**RECEIVE AND FILE COMMUNICATION FROM THE
PLAN AND ZONING COMMISSION REGARDING REQUEST FROM
14 WALNUT, LLC FOR VACATION OF SUBSURFACE, SURFACE, AND AIR RIGHTS
WITHIN PORTIONS OF FALCON DRIVE, WALNUT STREET, 14TH STREET, AND
THE NORTH/SOUTH ALLEY, ALL ADJOINING 1400 WALNUT STREET**

- E) Review and approval of a Site Plan "Walnut Apartments" under design guidelines for multiple-family dwellings, to allow the development of a 5-story mixed-use building with 90 residential units, 2,450 square feet of first floor retail/office space, and 49 spaces of below grade off-street parking.

RE: Walnut Apartments – 1400 Walnut Street

11-2016-1.23

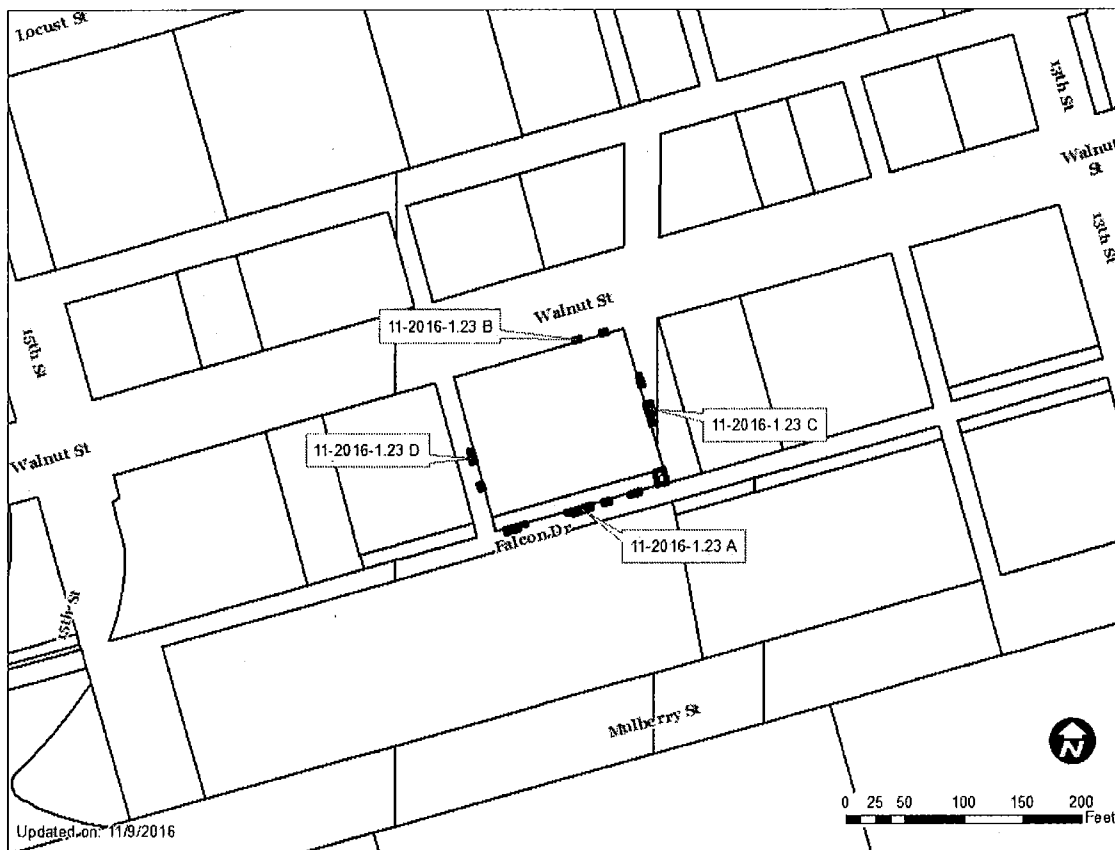
- A) Vacation of subsurface, surface, and air rights within the northern portion of Falcon Drive adjoining 1400 Walnut Street, to allow for balcony, subsurface building footing and surface door and gate encroachments.
- B) Vacation of surface and subsurface rights within the south 1 foot of Walnut Street adjoining 1400 Walnut Street, to allow for subsurface building footing and doorway stoop encroachments.
- C) Vacation of subsurface and air rights within the west 3 feet of 14th Street adjoining 1400 Walnut Street, to allow for balcony and subsurface building footing encroachments.
- D) Vacation of surface and air rights within the east 3.5 feet of the north/south alley west of and adjoining 1400 Walnut Street, to allow for balcony and doorway encroachments.

10-2017-7.39

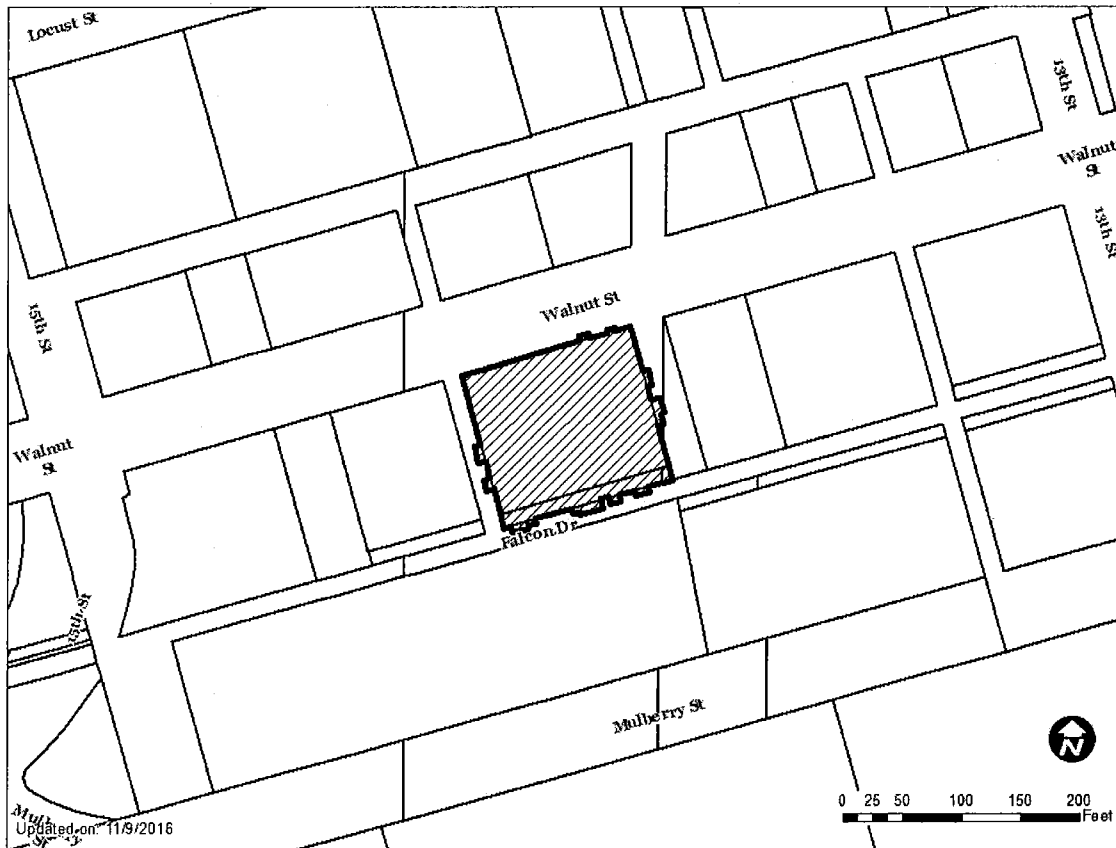
1. Compliance with all administrative review comments of the City's Permit and Development Center.
2. Any brick veneer on the structure shall be full-dimensional brick and provide appropriate architectural detailing around windows and doors, to the satisfaction of the Planning Administrator.

3. Additional architectural detailing shall be provided around the windows for the residential units on the street level of the north façade, to the satisfaction of the Planning Administrator.

4. The developer shall work with staff to come up with an acceptable design for the surface area on the east and west façades of the structure to the satisfaction of the Planning Administrator.

5. The portions of the east, south, and west facades of the structure clad with cementitious panels shall provide additional articulation and/or detailing to the satisfaction of the Planning Administrator.

6. The developer shall be required to maintain the brick surface on the adjoining segment of 14th Street.
7. The gates screening the transformer and generator shall be solid steel that is painted to complement the structure.
